NVM Express Workgroup c/o VTM, Inc. 3855 SW 153<sup>rd</sup> Drive Beaverton, OR 97003 USA info@nvmexpress.org **NVM Express® Technical Proposal for New Feature**

Technical Proposal ID	TP 4156 Reachability Architecture
Change Date	2023-08-04
Builds on Specification	NVM Express Base Specification 2.0c
	TP4130 Cross Namespace Copy
References Specification	TP4091 Computational Programs
	TP4131 Subsystem Local Memory

Define a reachability architecture that applies to Cross Namespace Copy, Computational Programs, and Subsystem Local Memory

Figure FIGTBD7: Reachability Associations Example

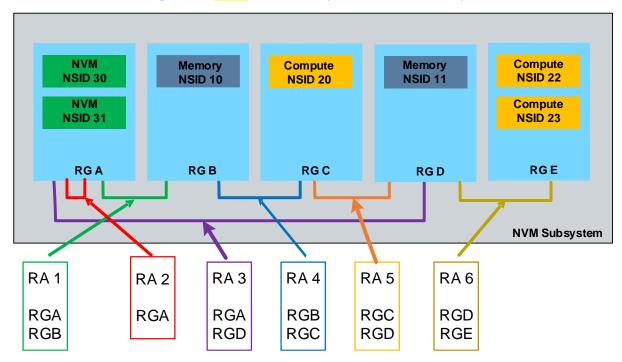
Figure FIGTBD7 is an example configuration that shows that:

- Reachability Association 1 (i.e., RA 1) :
  - o specifies that:
    - NSID 10 and NSID 30 are able to reach each other; and
    - NSID 10 and NSID 31 are able to reach each other;

- does not specify any reachability between NSID 30 and NSID 31;
- Reachability Association 2 (i.e., RA 2) is a self-reference for Reachability Group A (i.e., RG A) that specifies:
  - that NSID 30 and NSID 31 are able to reach each other;
- Reachability Association 3 (i.e., RA 3):

- o specifies that:
  - NSID 11 and NSID 30 are able to reach each other; and
  - NSID 11 and NSID 31 are able to reach each other;

- does not specify any reachability between NSID 30 and NSID 31;
- The lack of a Reachability Association that contains Reachability Group B (i.e., RG B) and Reachability Group D (i.e., RG D) specifies:
  - that NSID 10 and NSID 11 are not able to reach each other;
- The lack of a self-referencing Reachability Association for Reachability Group E (i.e., RG E) specifies:
  - that NSID 22 and NSID 23 are not able to reach each other.
